STAFF RECOMMENDATION 1712 Fifth Avenue North September 20, 2017

Metropolitan Historic Zoning Commission
Sunnyside in Sevier Park
3000 Granny White Pike
Nashville, Tennessee 37204
Telephone: (615) 862-7970
Fax: (615) 862-7974

Application: Addition and Alterations - violation
District: Salemtown Neighborhood Conservation Zoning Overlay
Council District: 19
Map and Parcel Number: 08205003400
Applicant: Saint Petka Serbian Orthodox Church
Project Lead: Melissa Sajid, melissa.sajid@nashville.gov

Description of Project: A cupola addition was constructed, windows replaced and brick cladding removed without a Preservation Permit.

RENOVATION OF EXISTING

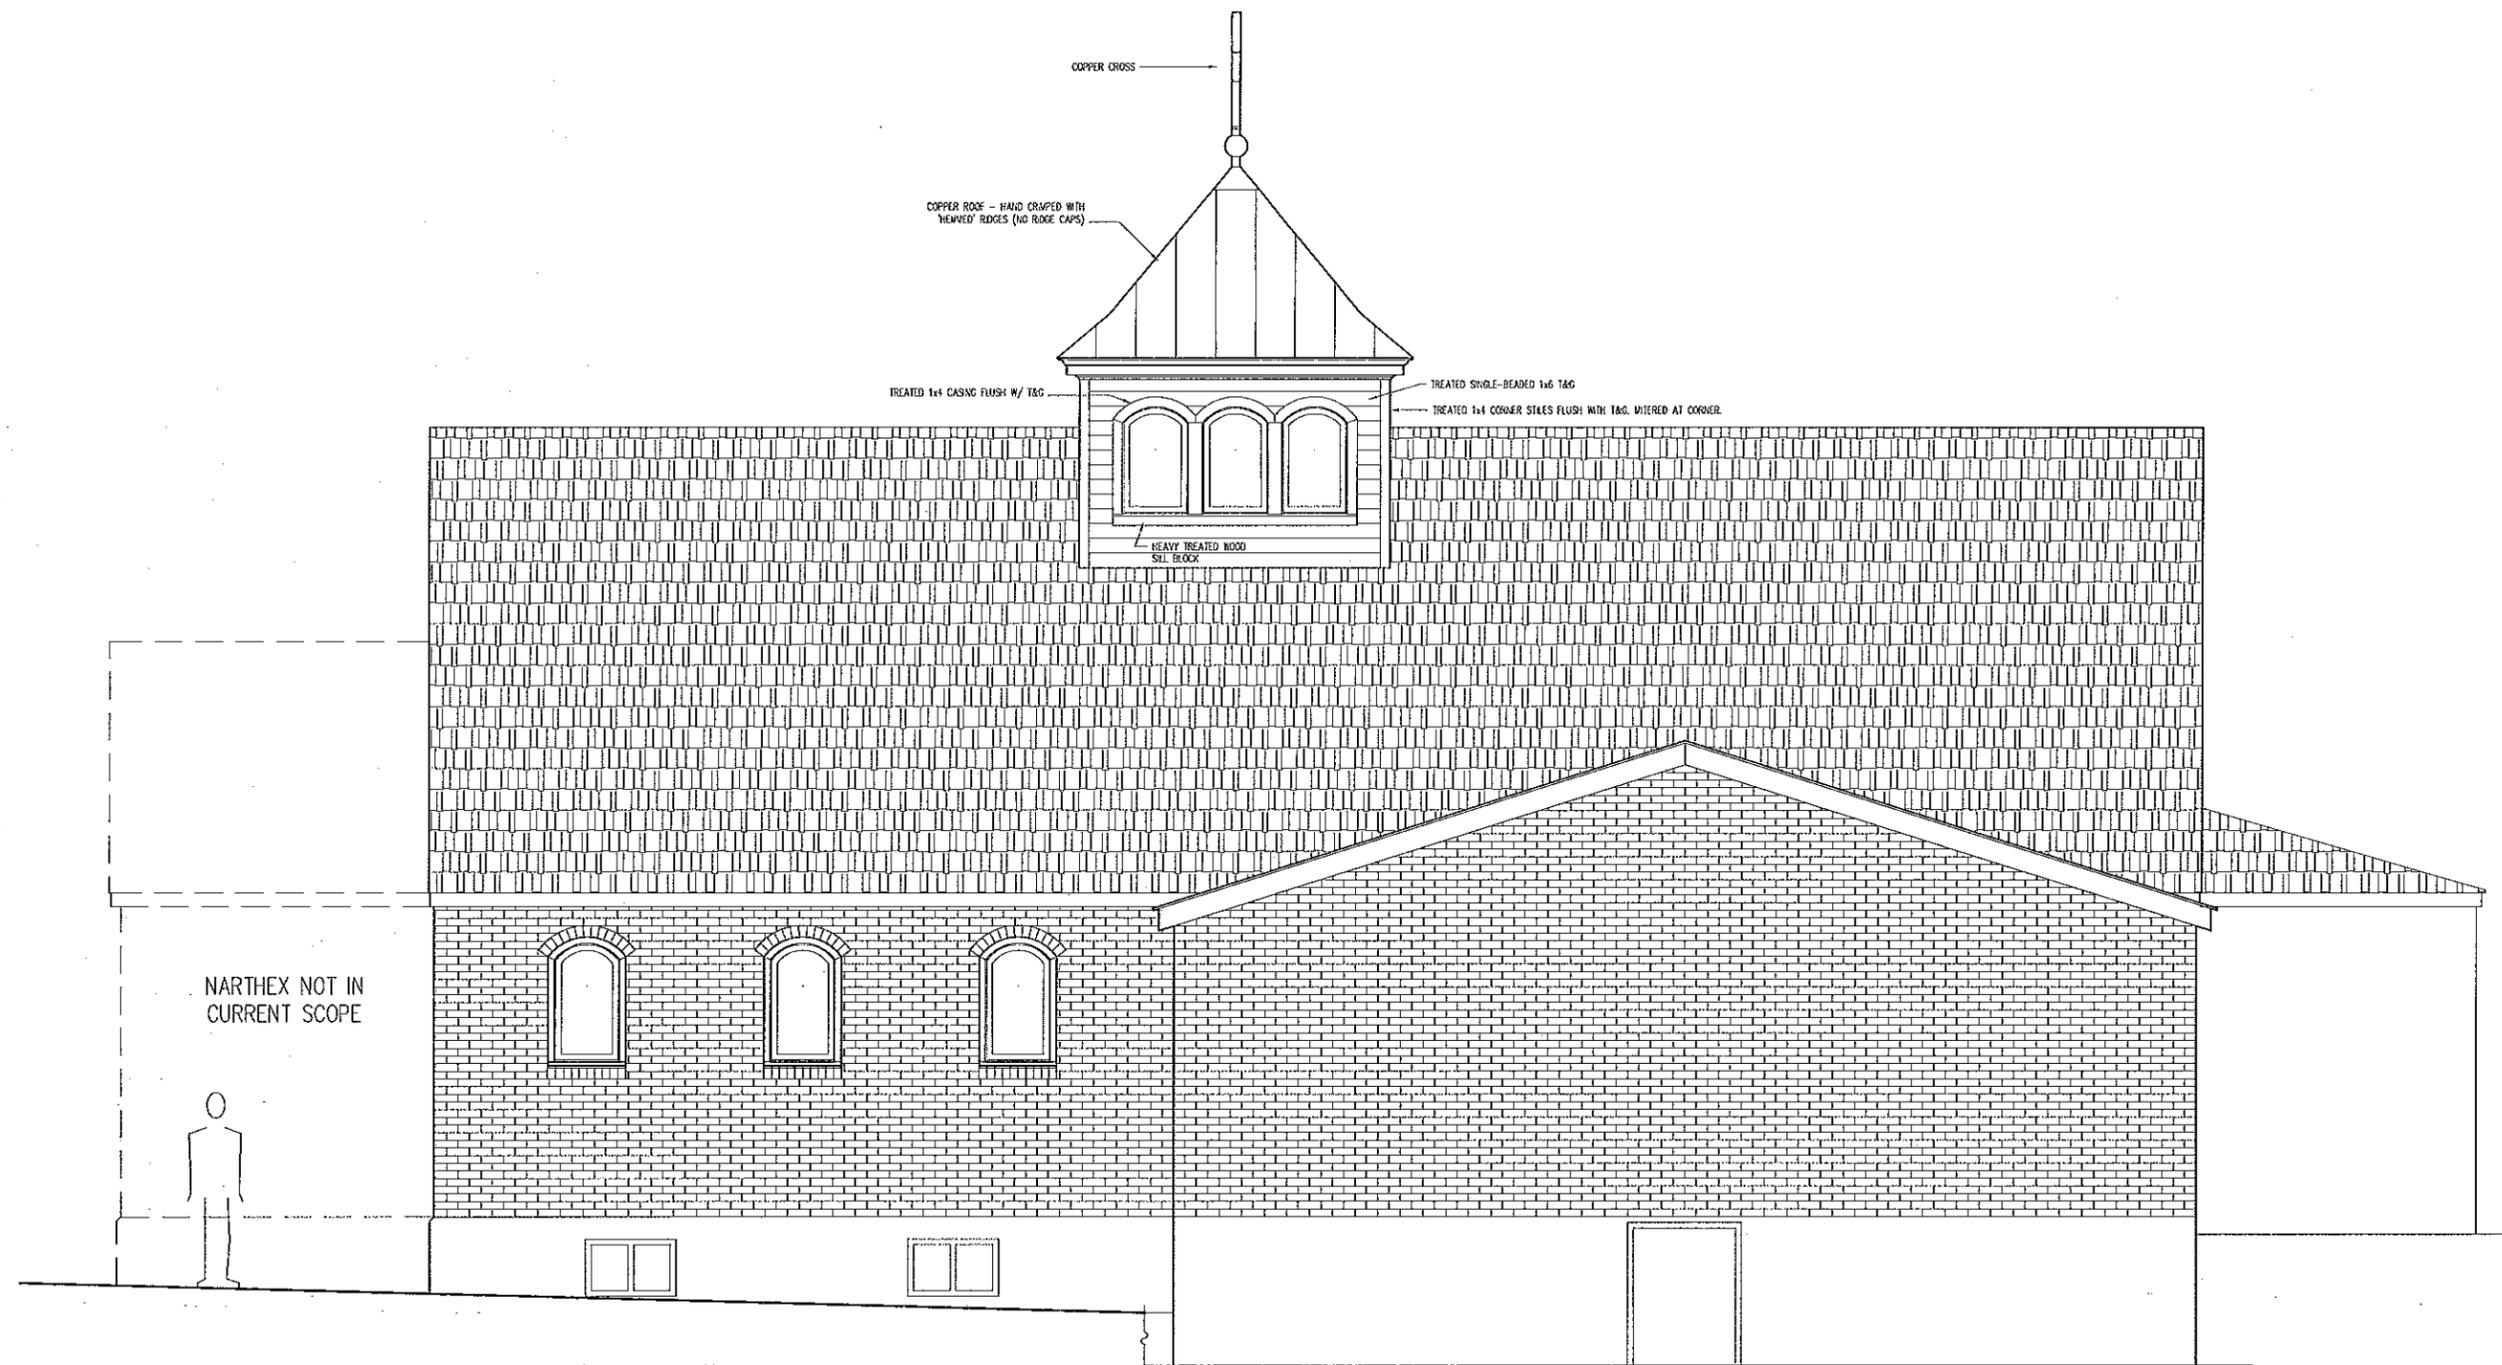
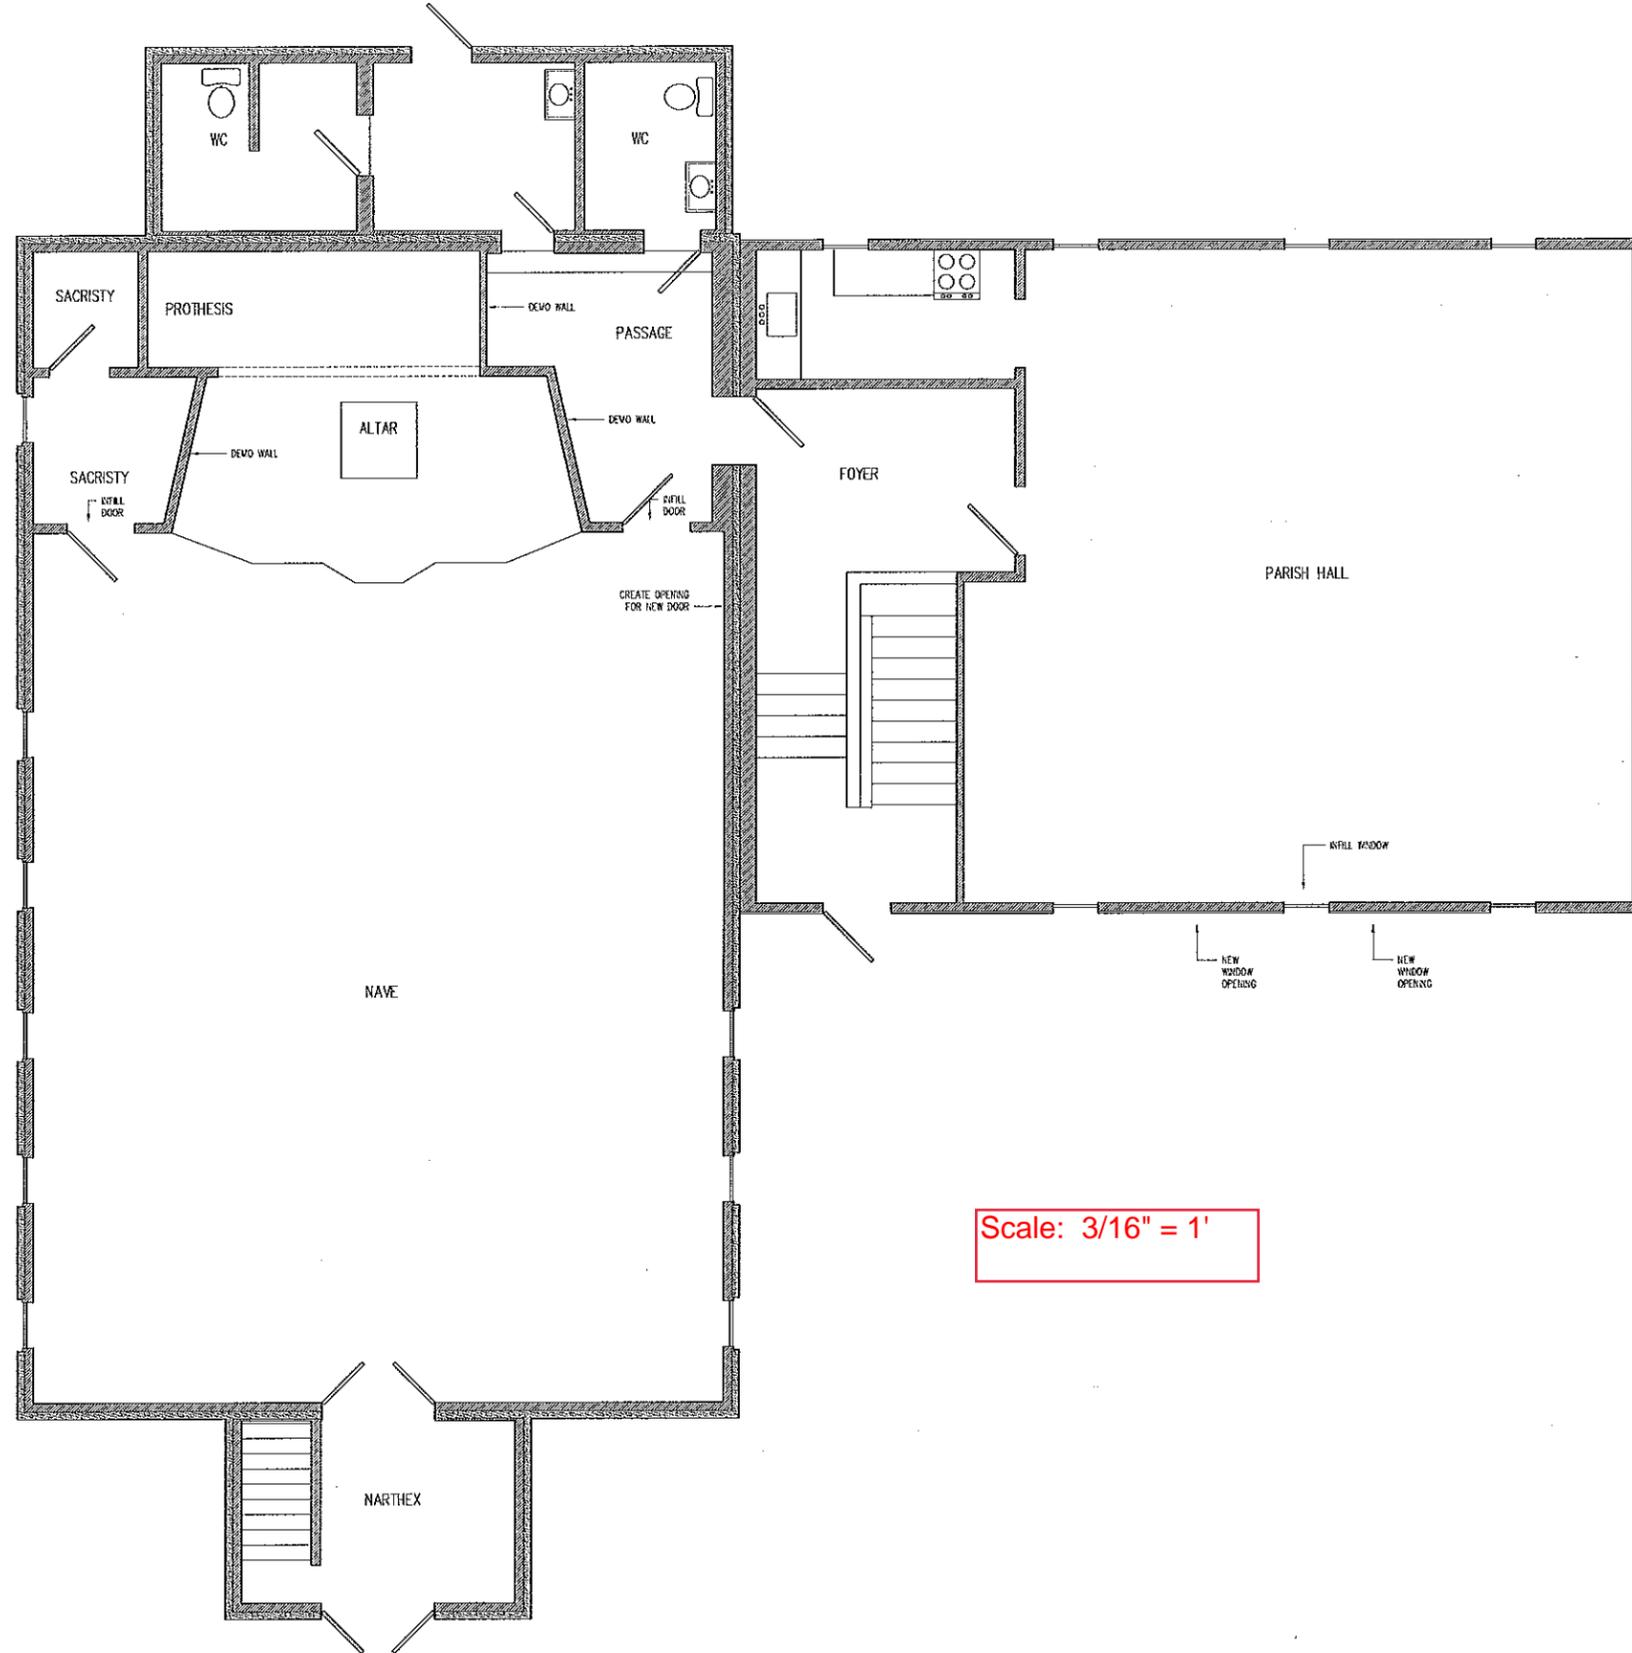
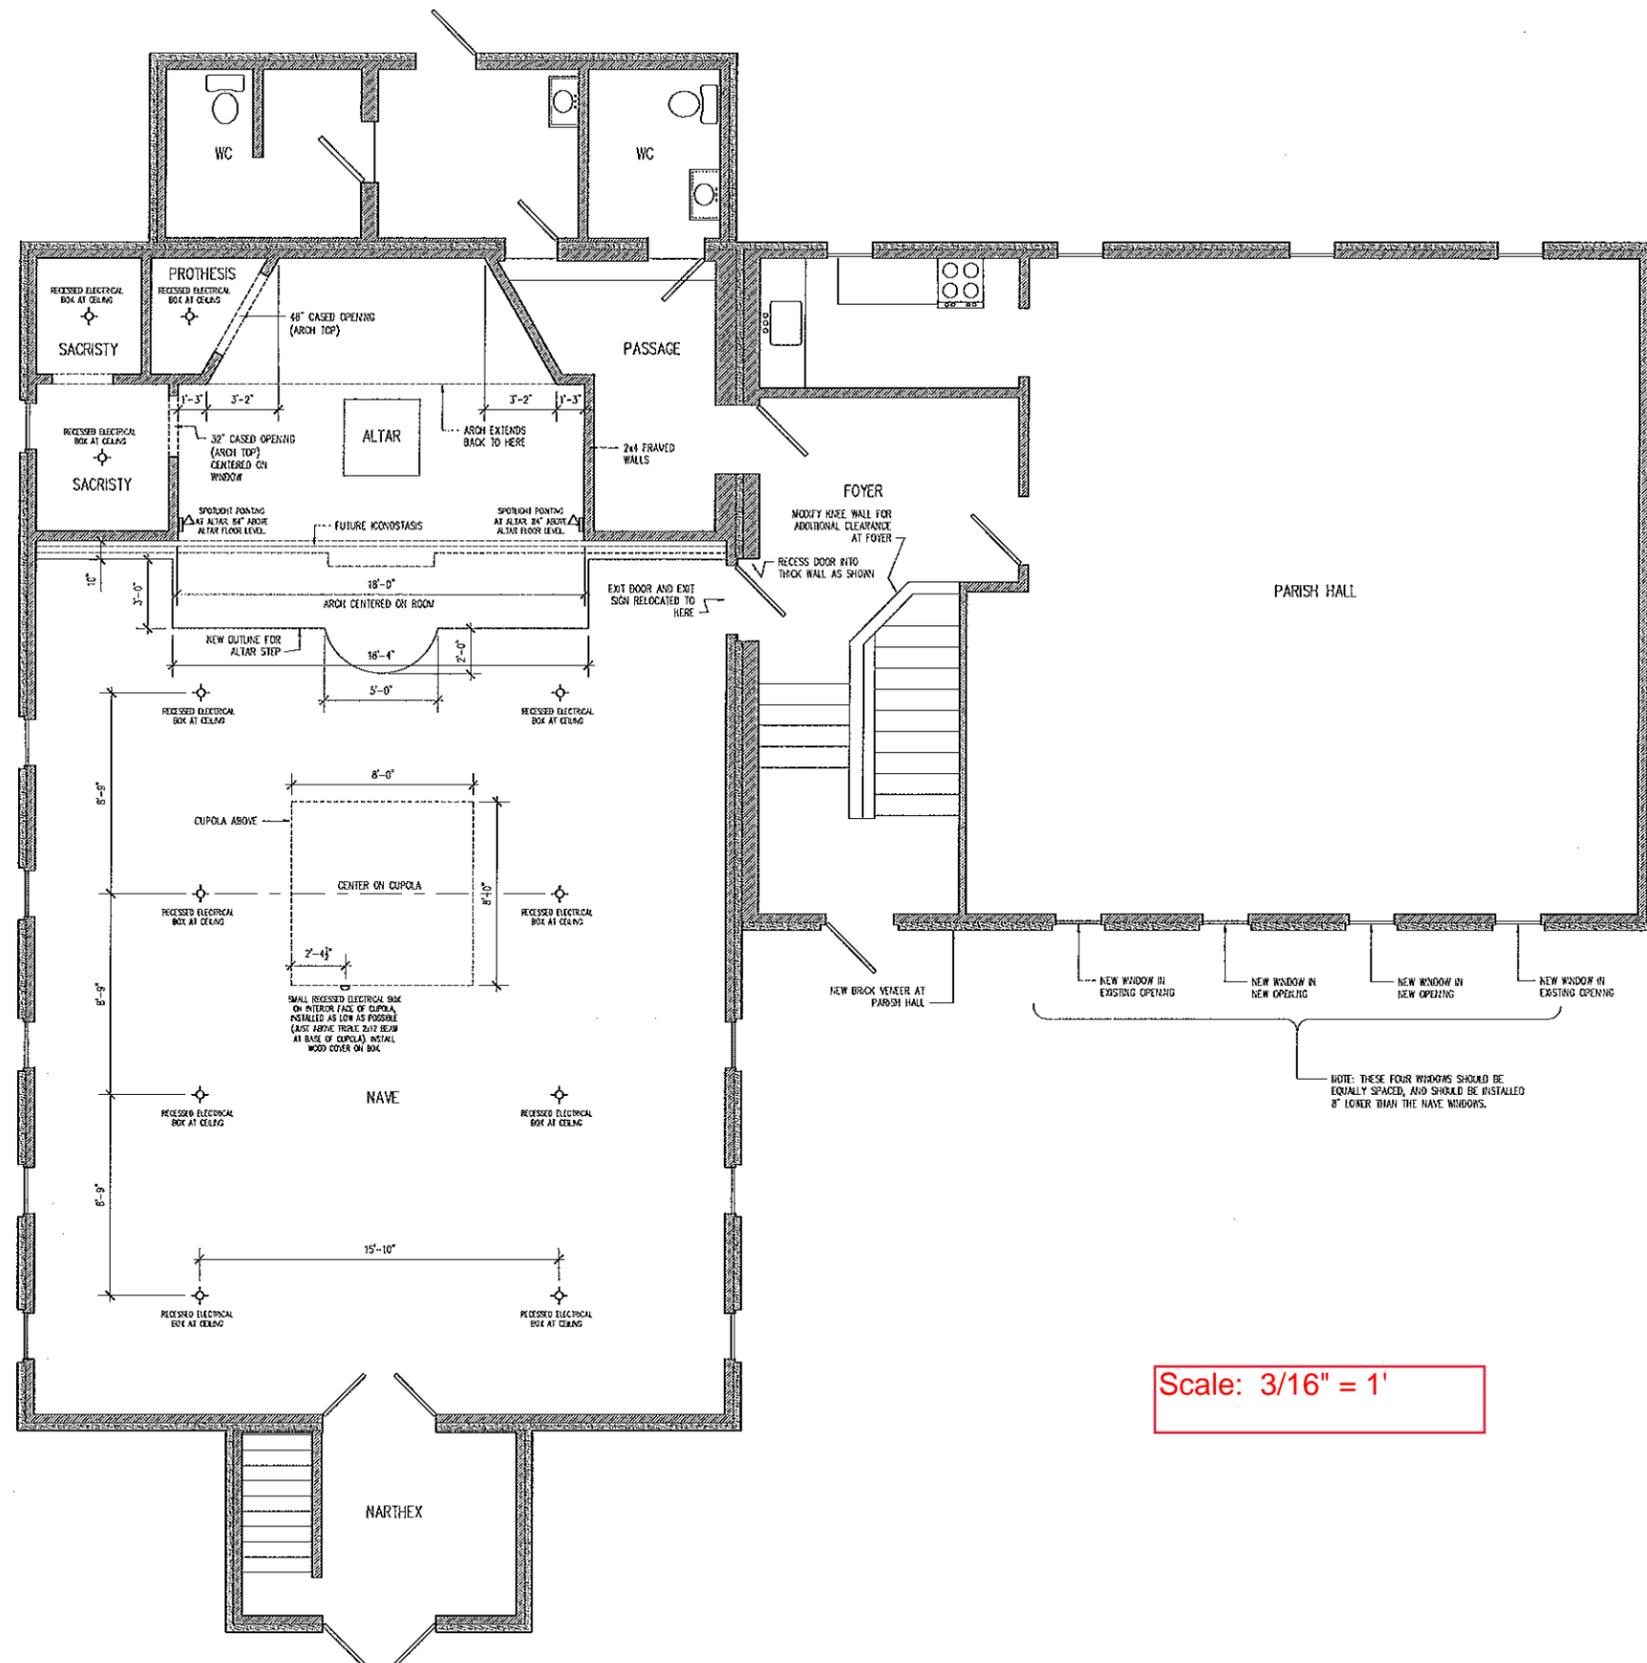
The applicant added a cupola to the primary roof of the historic church.

Location & Removability: The design guidelines call for additions to be located at the rear of buildings in a manner where it does not affect the historic form and character of the building. Cupolas are not listed as an appropriate type of rooftop addition. The Secretary of Interior’s Standards do not allow for the addition of “conjectural details.” Finding that the addition changes the historic building’s original form and design, the project does not meet section II.C. of the design guidelines for additions, II.A for location and I.B.3 of the Secretary of Interior’s Standards.

Design: Staff finds the design of the cupola to be inappropriate since it is not replicating a historic feature. The cupola contrasts greatly with the size and scale of the historic church. There is no evidence that the simple design of this historic church had a cupola. The project does not meet section II.E of the design guidelines.

All materials except for the windows meet the design guidelines. The applicant installed PlyGem 1500 Series vinyl windows, which the Commission has specifically not allowed. The project does not meet section III.D.

4. The cupola is removed and the original roof form restored to its original configuration with a roofing material to match the existing material.
5. The brick on the two sides of the historic portion of the church be altered so that the vertical stretchers that were located at the bottom of the brick wall (see figure 6) and above windows is reinstalled. No more historic brick is approved for removal.

6. The original window locations, dimensions, design and materials be reinstalled. The applicant shall submit drawings showing the original window dimensions and locations as well as information about materials for staff review, prior to making the change.
